SUBJECT: Duke Energy Corporation  
Catawba Nuclear Station Units 1 and 2  
Docket Nos.: 50-413 and 50-414  
Emergency Plan, Revision 03-1

Enclosed for NRC staff use and review is Revision 03-1 to the Catawba Nuclear Station Emergency Plan. This revision is effective on January 15, 2004.

**Catawba Nuclear Station  
Emergency Plan Revision 03-1  
Attachment 1  
Detailed Revision Description**

**FIGURE B-4**

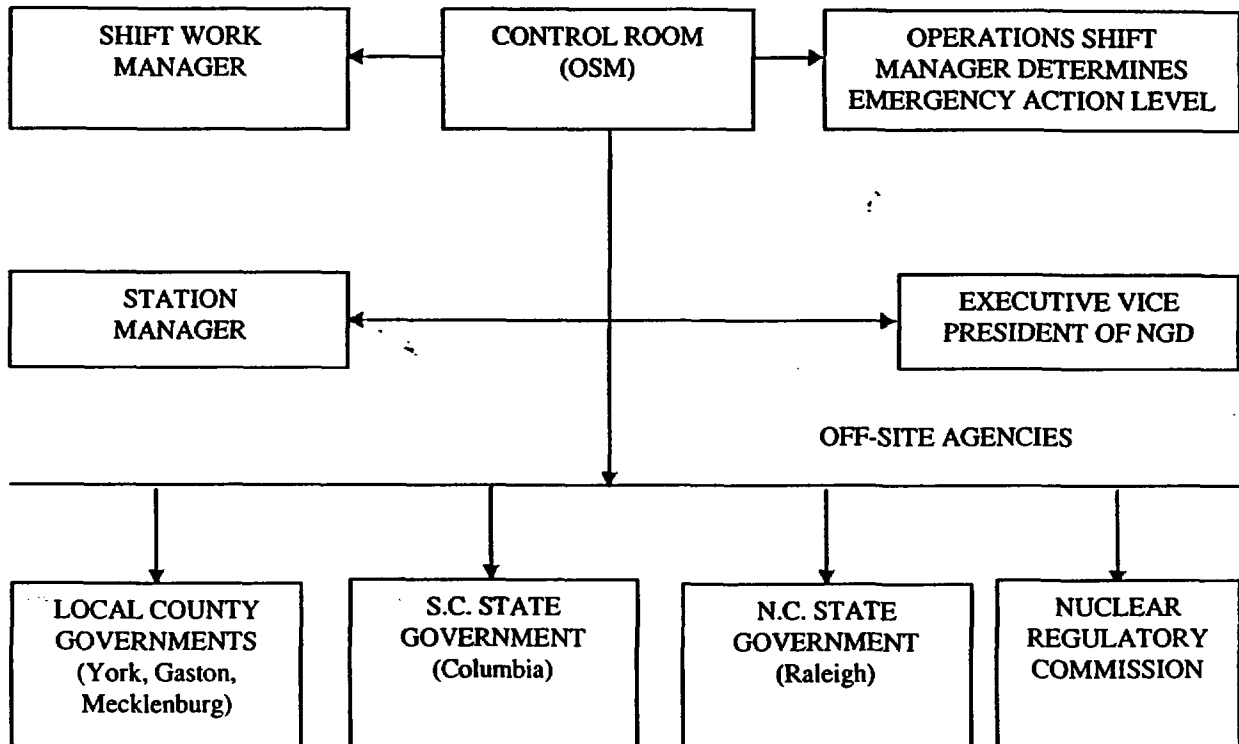
- On Figure B-4, page B-11, changing the name of Senior VP of NGD to "Executive VP of NGD" is editorial.

**FIGURE F-1  
CATAWBA NUCLEAR STATION  
CONTROL ROOM EMERGENCY COMMUNICATIONS  
PRIOR TO TSC ACTIVATION**

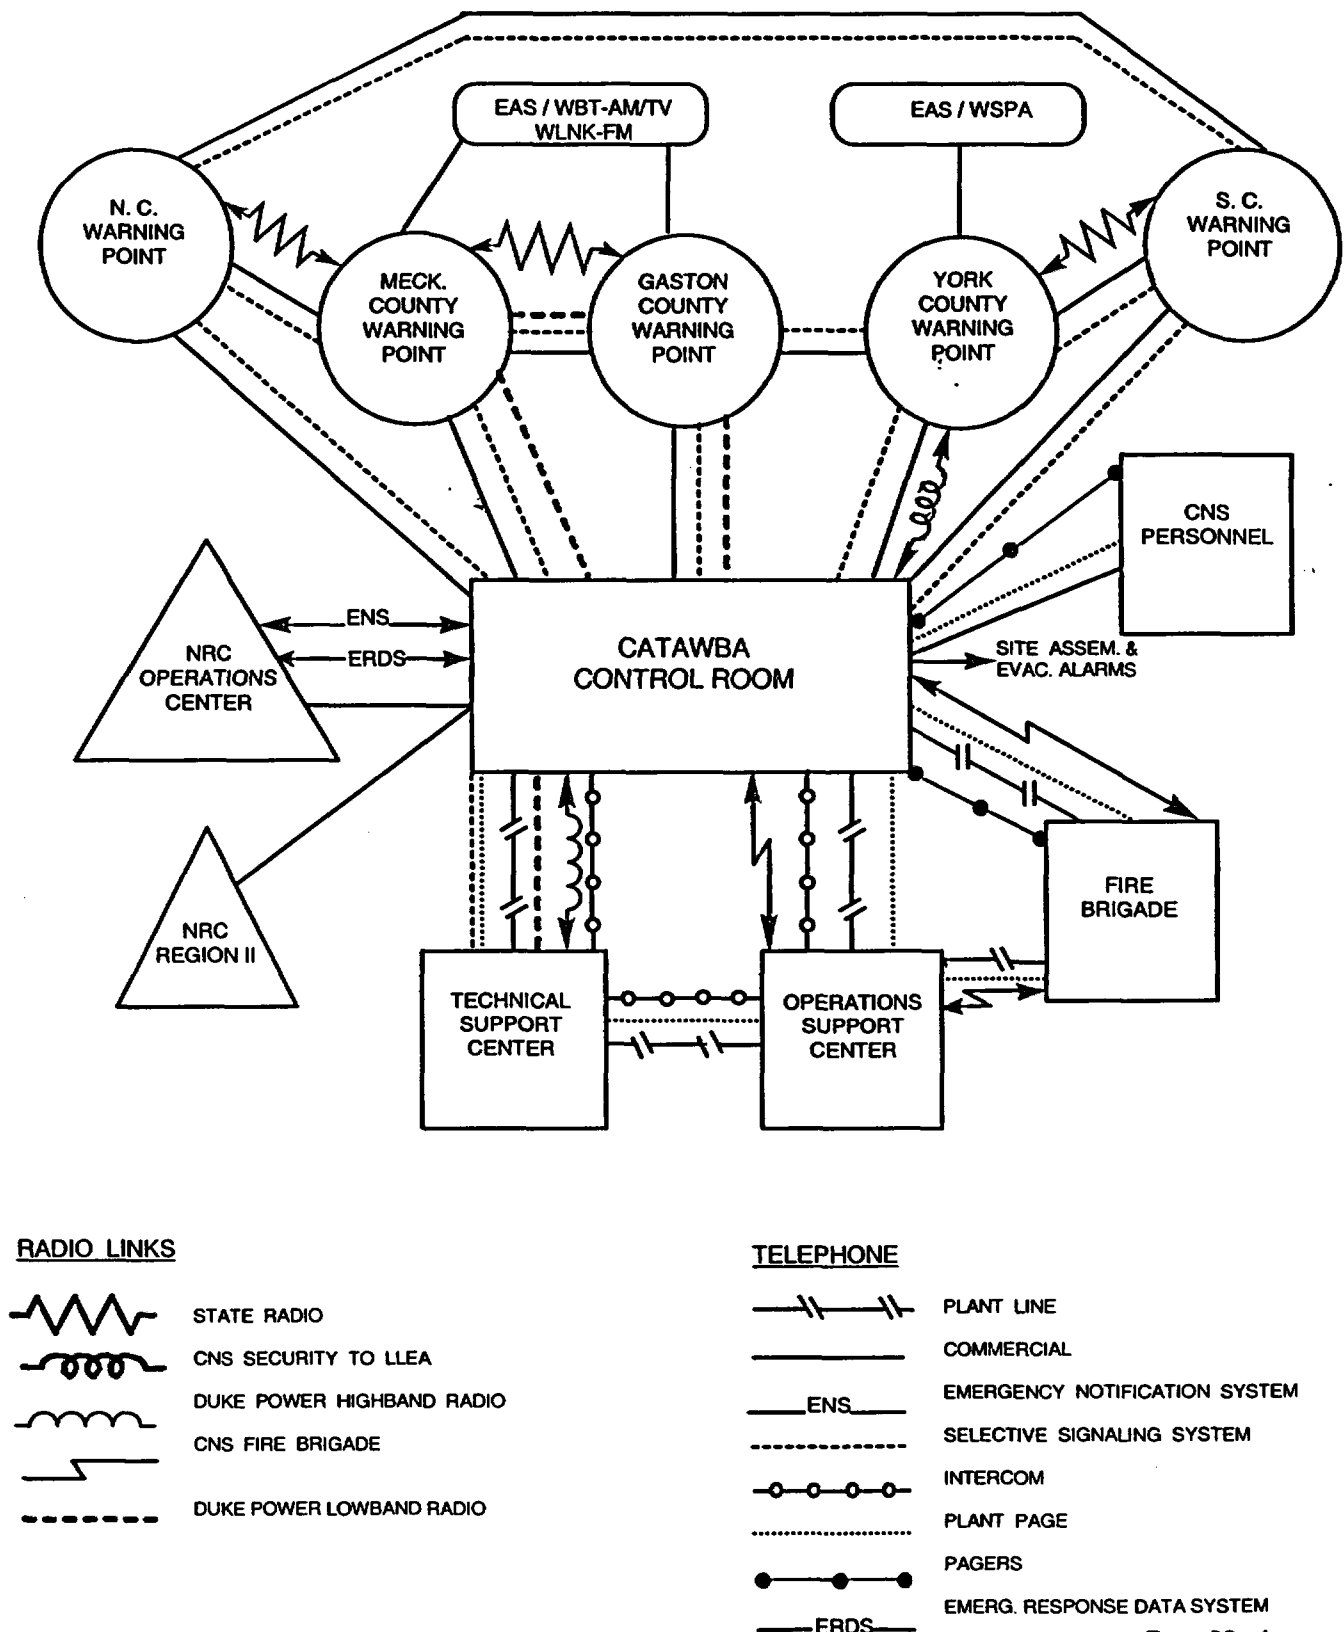
- The words added in section F.1.c are editorial and reflect that the TSC/EOF have HPN capability.
- Figures F-1 and F-2 were corrected to show that York County does not have a low band radio. There is no requirement to have this low band radio, and they have several other means of communications available.
- Figure F-2 was updated to show the state radio links that are available between Mecklenburg County, Gaston County, York County and Catawba TSC. This radio link has been available but was not shown on Figure F-2.

# CATAWBA NUCLEAR SITE FIGURE H-1 TECHNICAL SUPPORT CENTER (TSC)

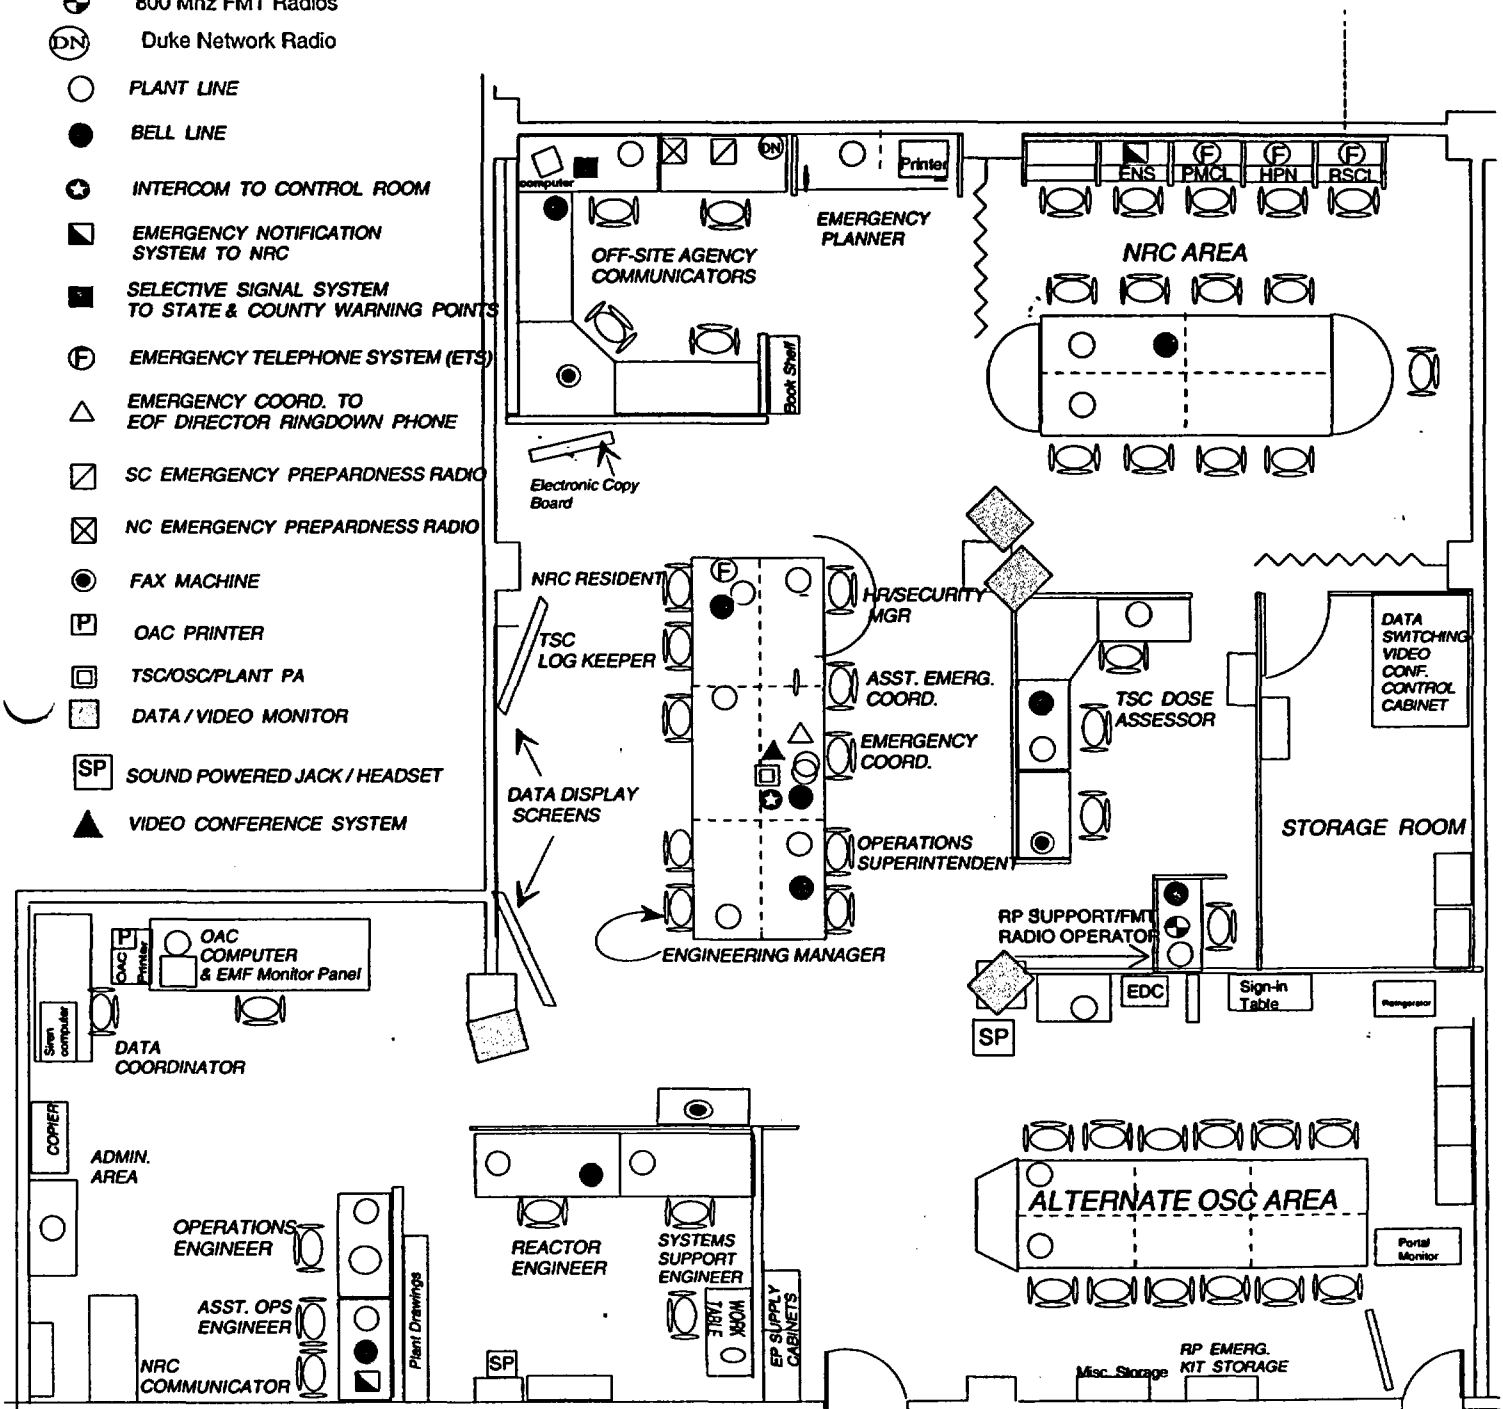
- Revised Section H.1.c on page H-2 to change "574" to "609" elevation and added the words, "with the OCC."
- Revised Figure H-1 on page H-7 to update the Technical Support Center drawing to match changes made in the TSC.
- Replaced Figure H-2 on page H-8 with a new drawing showing the location and layout of the new Operations Support Center. The new OSC is now co-located with the Outage Control Center (OCC) on the 609 elevation of the Service Building.

- Figure H-1 on page H-7 was revised to update the TSC facility drawing to match some minor changes in the facility. The changes made to the TSC consist of rearranging some tables and cabinets and some plant telephone line locations. The changes were made to better facilitate the flow of communications and enhance our business practices.

CATAWBA NUCLEAR SITE  
FIGURE H-2  
OPERATIONS SUPPORT CENTER  
(OSC)

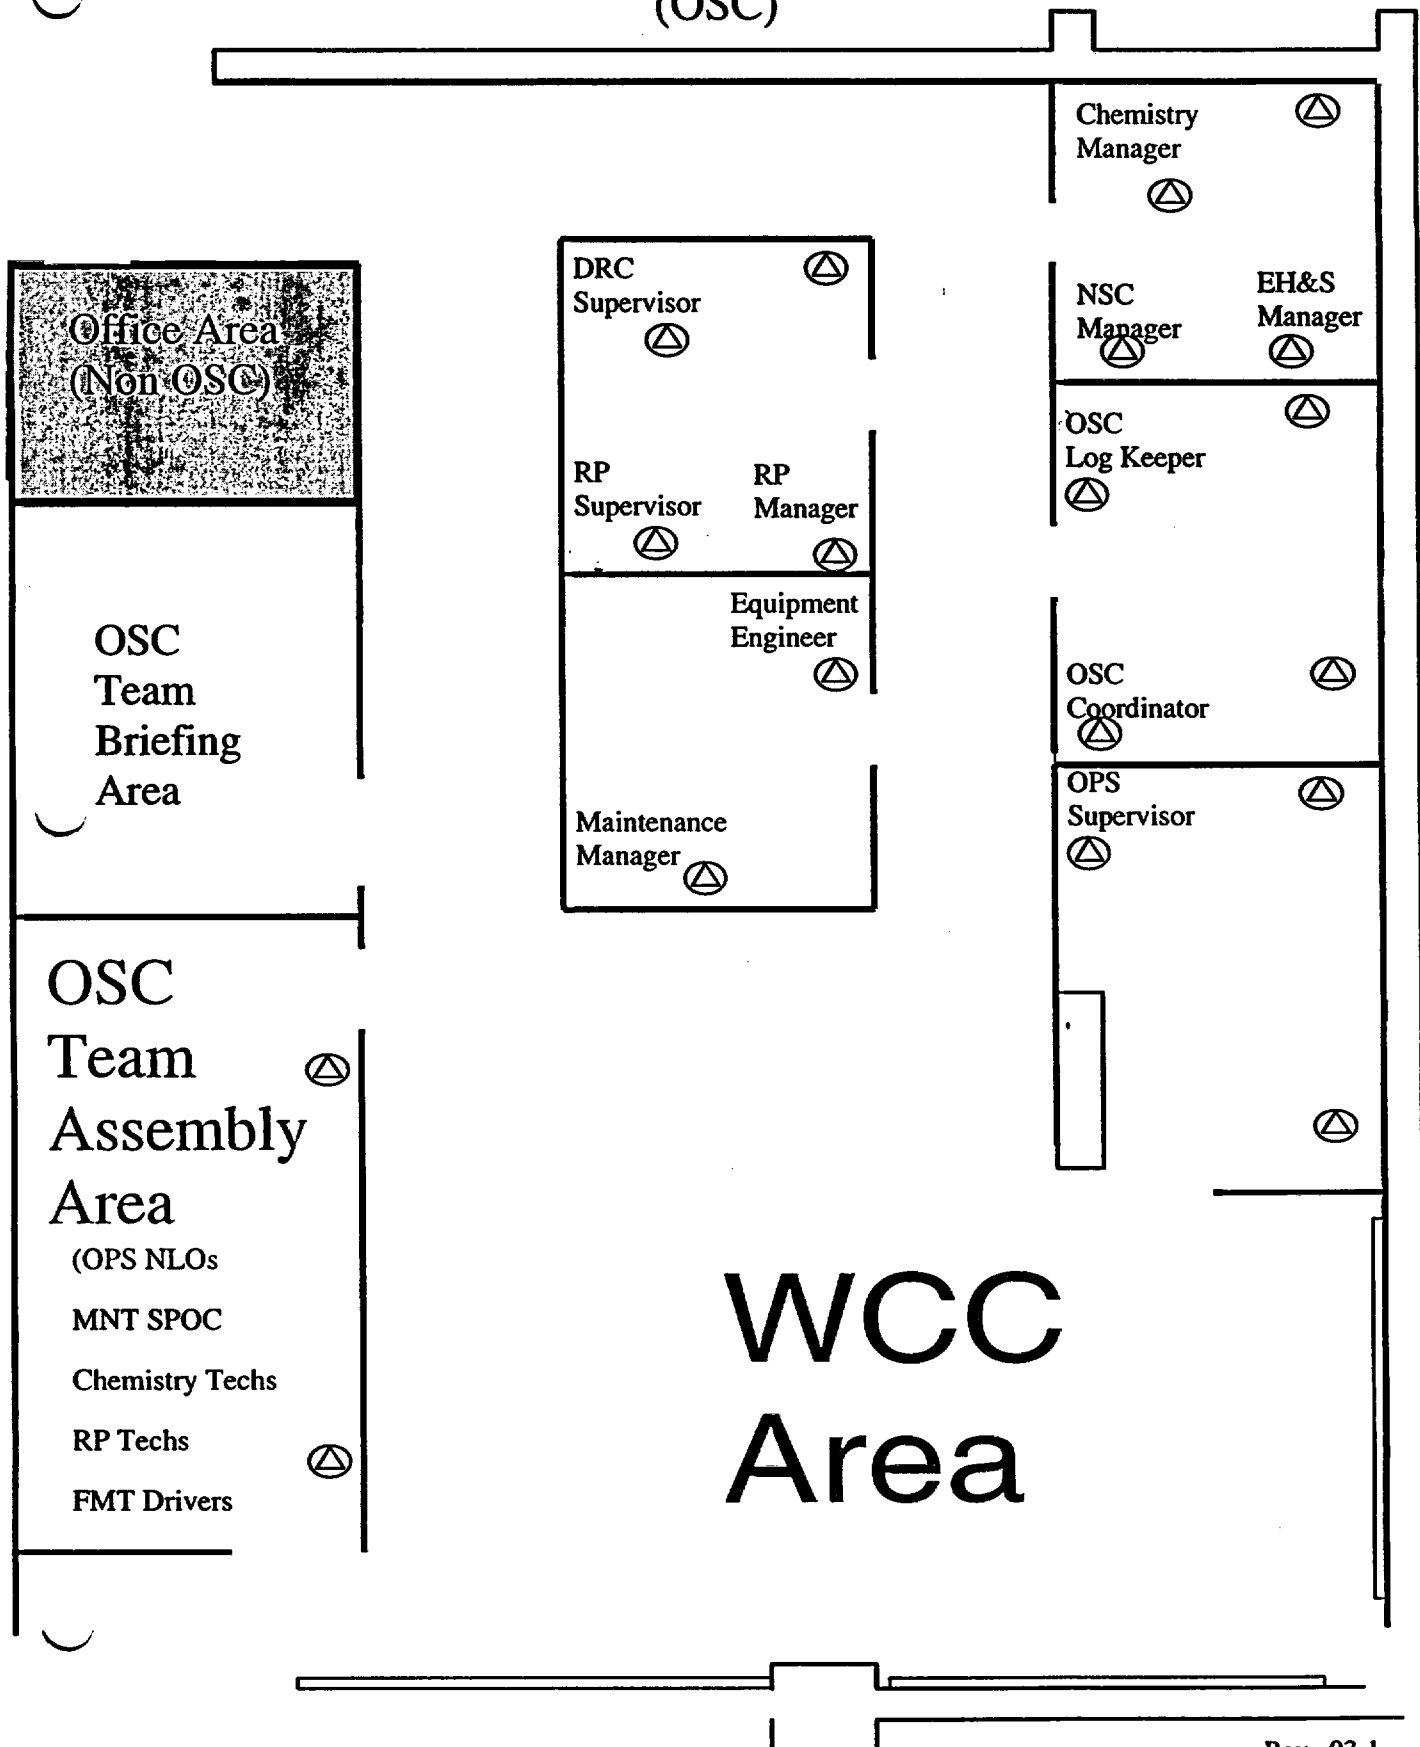
- Changes on page H-2 and Figure H-2 on page H-8 concern moving the OSC from 574 elevation of service building to 609 elevation of service building. The following is a copy of the 50.54q evaluation and justification for moving the OSC dated 8/4/03:

The OCC is an office-type area located next to the Site's Work Control Center (WCC) in the service building on elevation 609. The purpose of the OCC is to provide a common, central location for key outage management personnel during the execution phase of the outage. It may also be used by the Unit Threat Team when activation of a team is required. These are the only times the OCC is utilized.

The OCC area that will be utilized as the OSC is comparable to the area currently being used. The environment in this area is actually more conducive to facility command and control since it is much quieter than the current OSC (i.e.: no plant ventilation noise)
